## REGULAR MEETING CONSERVATION COMMISSION

4:00 P.M. July 9, 2025

## Memo

SUBJ: July 9, 2025 Conservation Commission Meeting

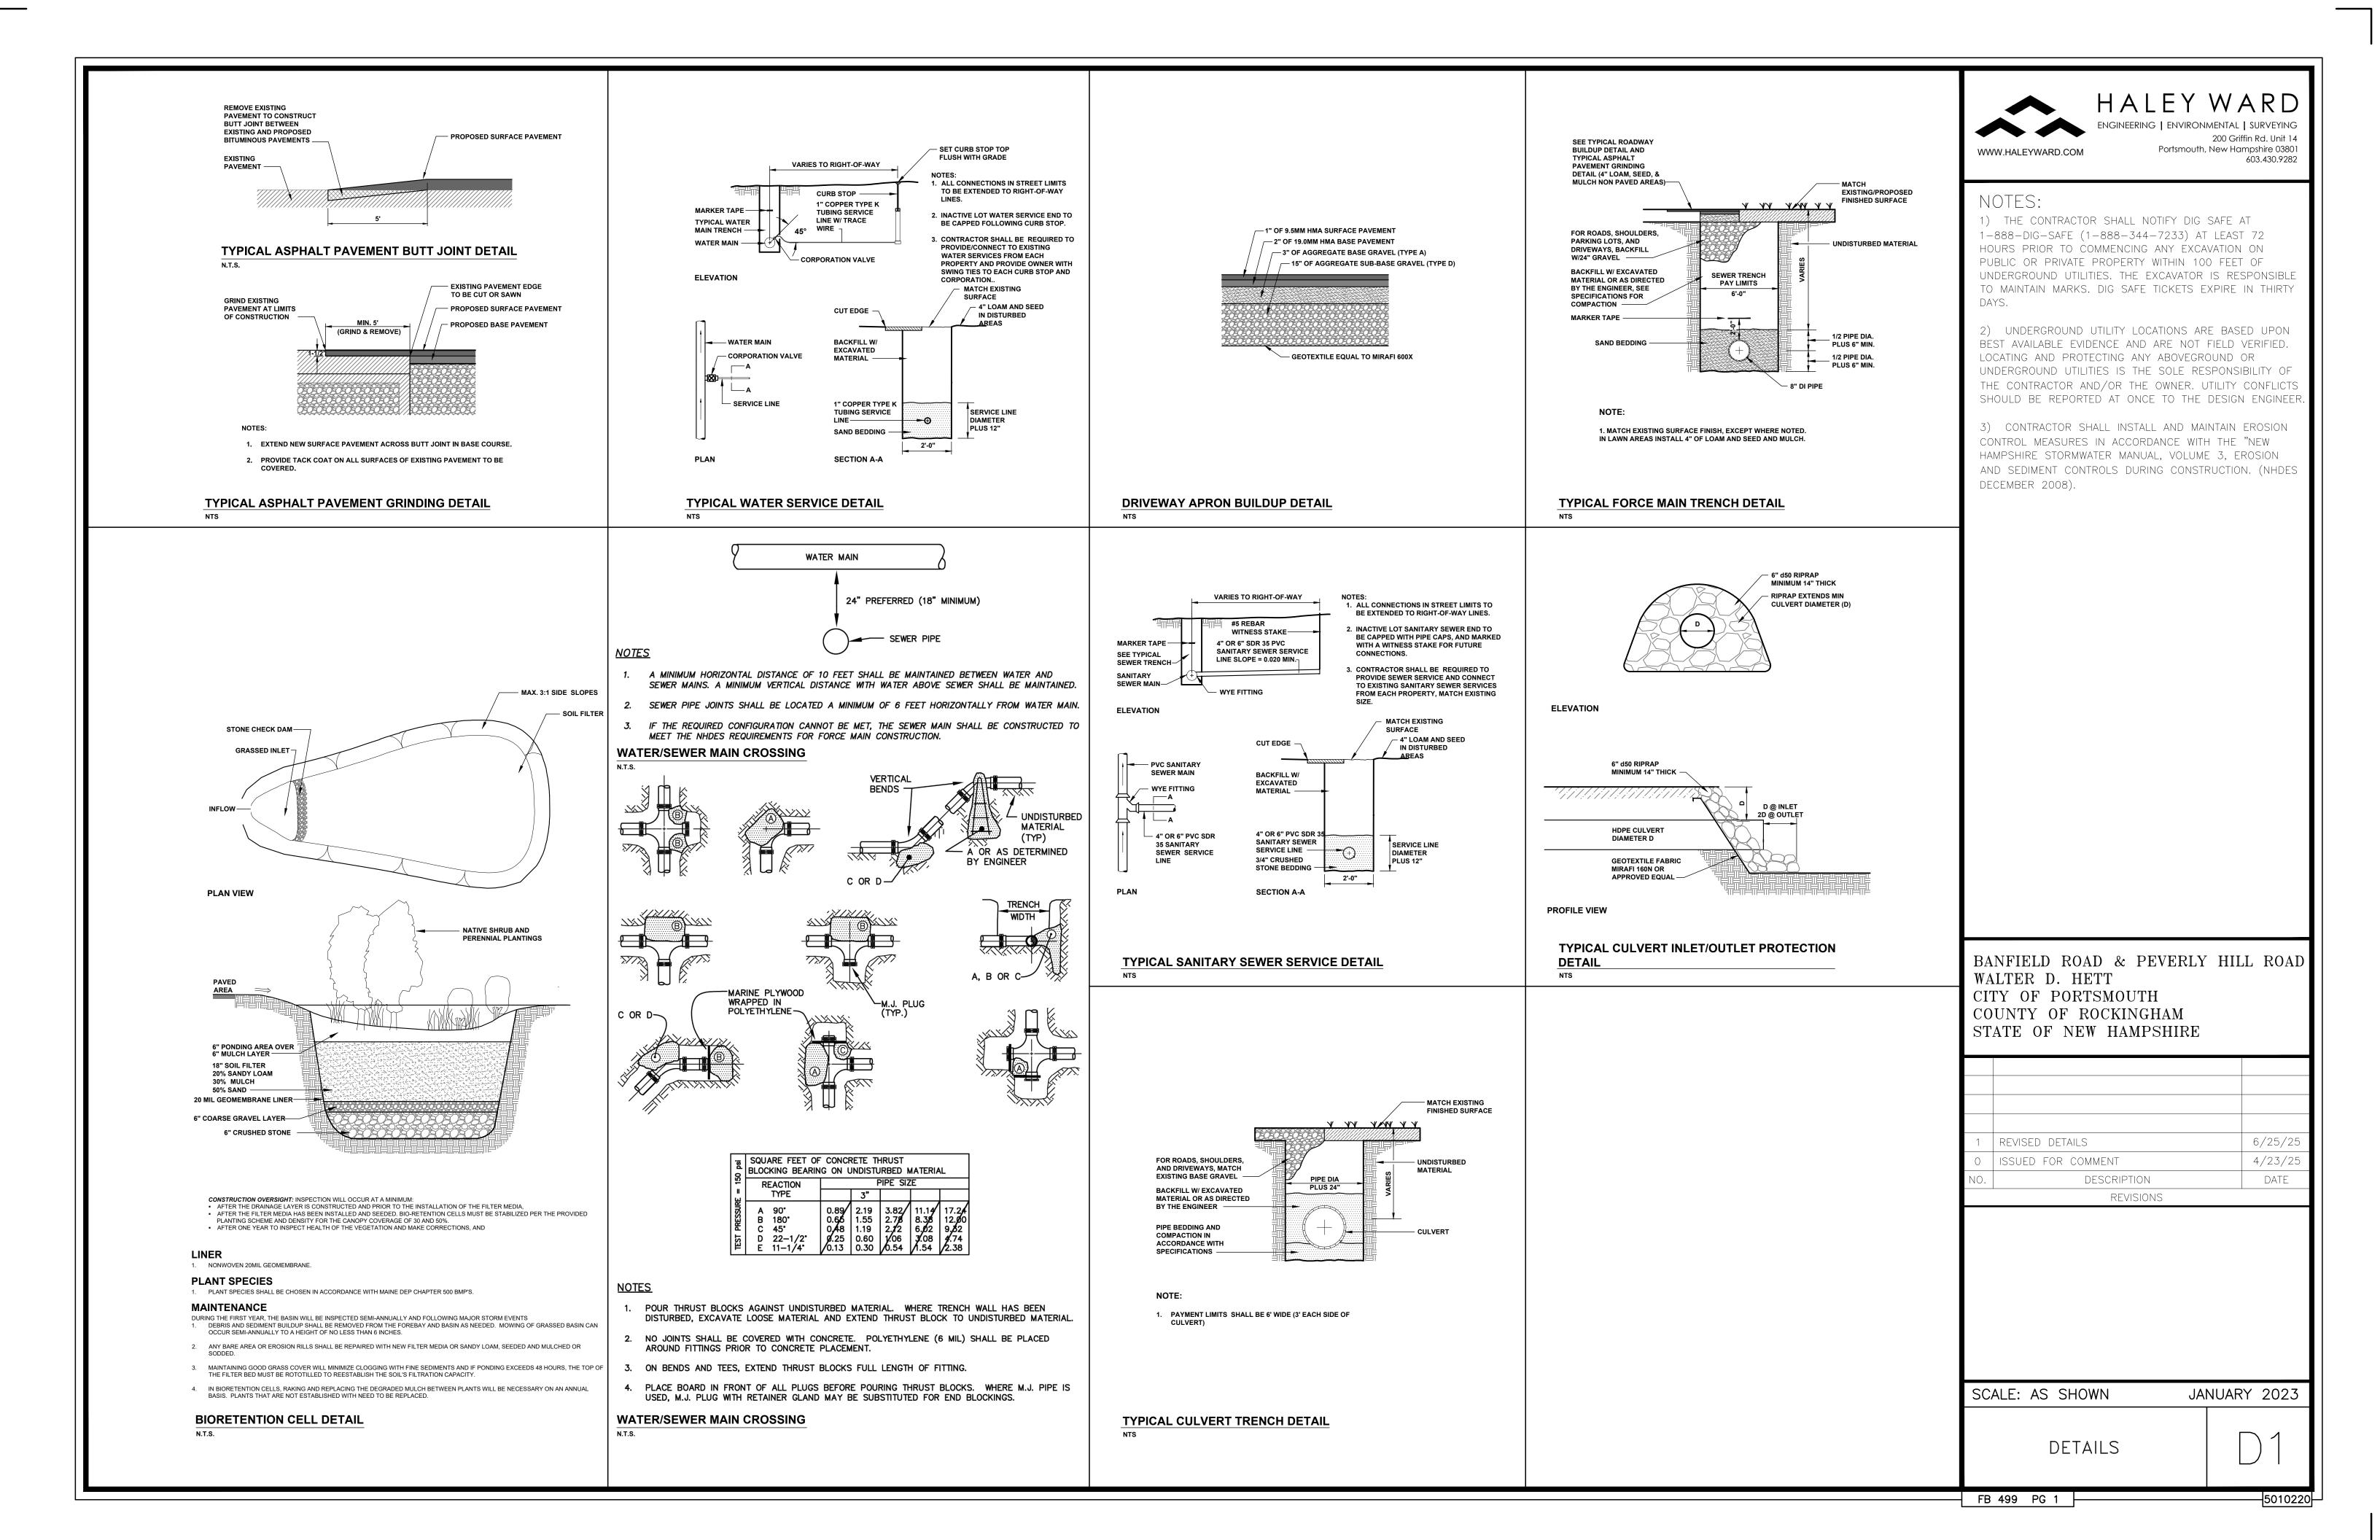
Impacts to the buffer include new impervious surfaces and construction of new utility and stormwater services. Applicant needs to show how stormwater runoff on site will be retained and treated. Current stormwater plans need to be finalized, and an erosion control plan must be provided.

The construction of the new services and driveways will likely have impacts on the existing tree line along Banfield and Peverly Hill Road. Applicant should clearly mark the trees to remain and to be removed on the plan set.

A planting plan is needed to determine this.

- 1. Wetland delineation shall be certified and stamped by a NH Certified Wetland Scientist (CWS).
- 2. Applicant should explore alternative plan with one shared driveway entering Lot 3 between the buffer setbacks to provide access to Lots 4 and 5.
- 3. Exact dimensions, location and a detail sheet are needed for the proposed rain gardens.

- 4. Erosion and sediment control plans must be included in this application, not just the building permit phase.
- 5. Application checklist is not complete, please address how this application complies with the following sections in the City of Portsmouth Zoning Ordinance:
  - a. 10.1017.24
  - b. 10.1017.25
  - c. 10.1018.31
  - d. 10.1018.32
  - e. 10.1018.40
- 6. Applicant should propose buffering or protection along each of the lots that protects the natural vegetated state of the prime wetland and its 100' buffer to the rear of the site.
- 7. Applicant shall include a planting plan in the plan set. This should also show vegetation to remain and to be removed.
- 8. Applicant must clearly define and address areas to be filled and areas to be regraded on the plans.
